Customer Service Notice

Units Affected: Units installed at Elizabethtown Final Assembly on Ford F550 chassis with 19,500 lbs GVWR (see attached list)

Battery Cable Routing Change

Figure 1 — Cable Routing (View looking under chassis)

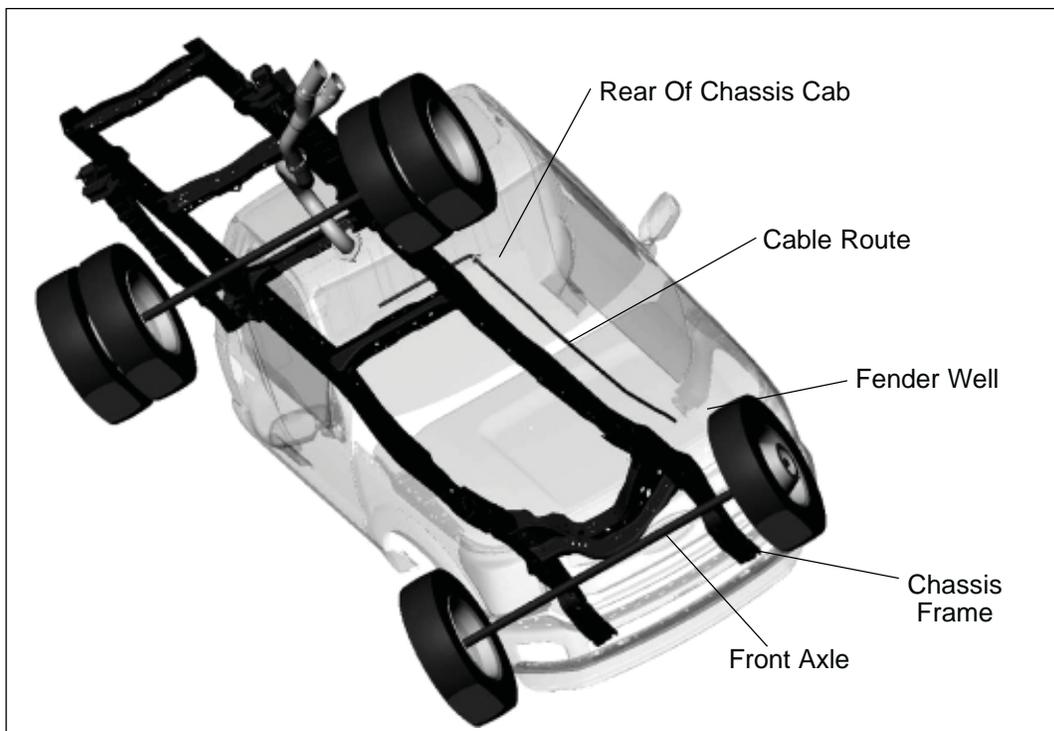
A design change in the 2010 model Ford F550 chassis decreased the spacing between the exhaust and the passenger side chassis frame rail. This led to routing of the battery cables for accessory items such as DC pumps, inverters, etc. in a manner in which the cables could be damaged (refer to Figure 1). Cables are now being routed in current production so they no longer pass between the cab and the frame eliminating the potential of being damaged.

Altec requires that all affected units have the battery cables rerouted within 90 days from receiving this CSN or at the next service interval, whichever is earliest. If the cables are found to be damaged or too short to reroute, they must be replaced. Damage may not be visible until part of the inspection is performed.

Figure 2 — Battery Connections

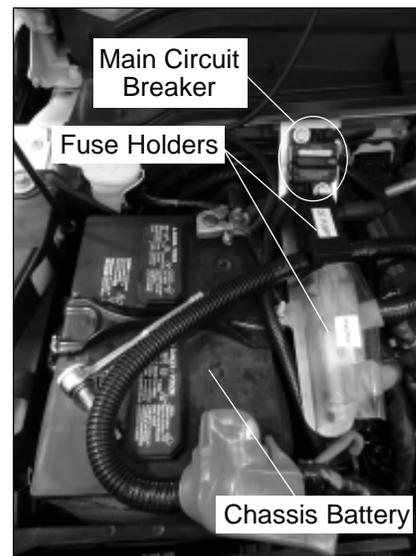
1. Locate the chassis battery and disconnect the main circuit breaker (refer to Figure 2). Remove the accessory fuses (for inverter, DC pump, etc.) from the fuse holders on top of the battery.
2. Disconnect the cables from the main circuit breaker and the fuse holders that go to the accessories at the aerial device, body or tail shelf. The short cables connecting the battery to the circuit breaker or fuse holder can remain connected.
3. Position the disconnected cables down the rear side of the fender well so the cables hang below the chassis cab.
4. Remove all clamps and ties holding the cables along the chassis frame under the cab. Save the clamps for use later. Remove the cables from behind the chassis rear cab mount bushing. The disconnected cables should now be loosely hanging at the rear of the cab.

Figure 3 — Hole On Bottom Rear Lip Of Cab (looking up from under chassis)

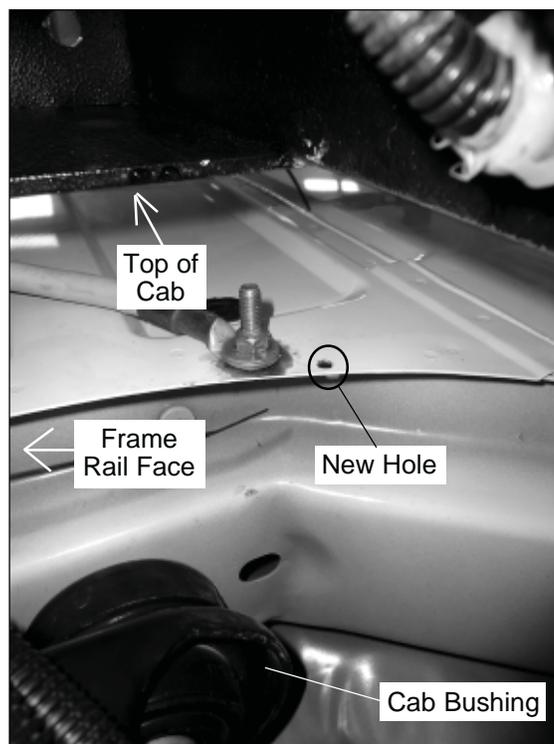
7. Drill a $\frac{5}{16}$ " diameter hole on the bottom rear lip of the cab, 1 inch from the bottom edge (refer to Figure 3). This hole should be outside of the cab bushing. The hole location should be approximately 6" from the face of the frame rail.

Figure 4 — Hole On Cab Understructure

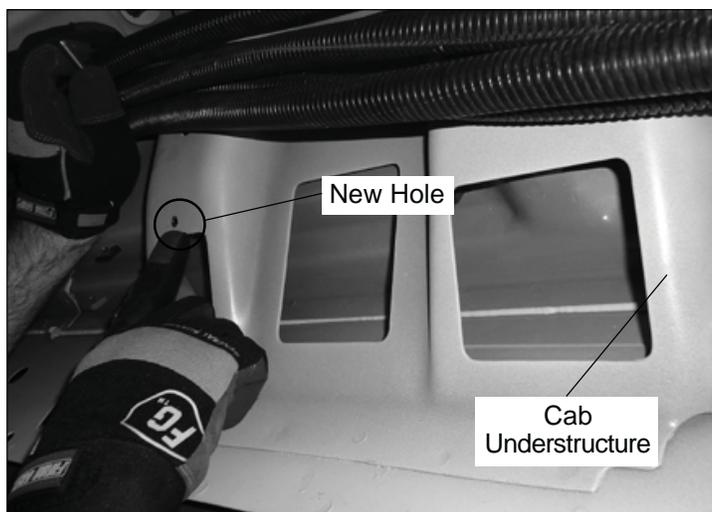
9. Drill a $\frac{5}{16}$ " diameter hole in the chassis cab understructure (refer to Figure 4). There is an access hole to reach the back of the drilled hole to install a nut. Use caution to drill only through the cab understructure and not the floor panel of the cab.
10. Drill a $\frac{5}{16}$ " diameter hole in the chassis cab understructure angle (refer to Figure 5). There is a stamped dimple at the end of the angle that should be used for the hole location.
11. Gather the loose cables into a bundle. Use electrician's tape to hold the bundle together for routing.
12. Continue to route the cables toward the front of the chassis, up the fender well, and into the engine battery area.

Figure 5 — Hole On Cab Understructure Angle

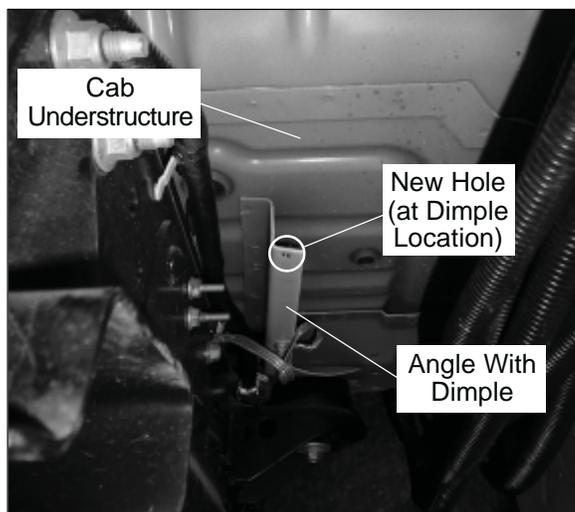
15. Use another clamp removed in Step 4 to attach the cable bundle to the understructure angle where the hole was drilled in Step 10. Use a 1^{1/4}" long cap screw and nut to secure the clamp to the cab understructure angle.
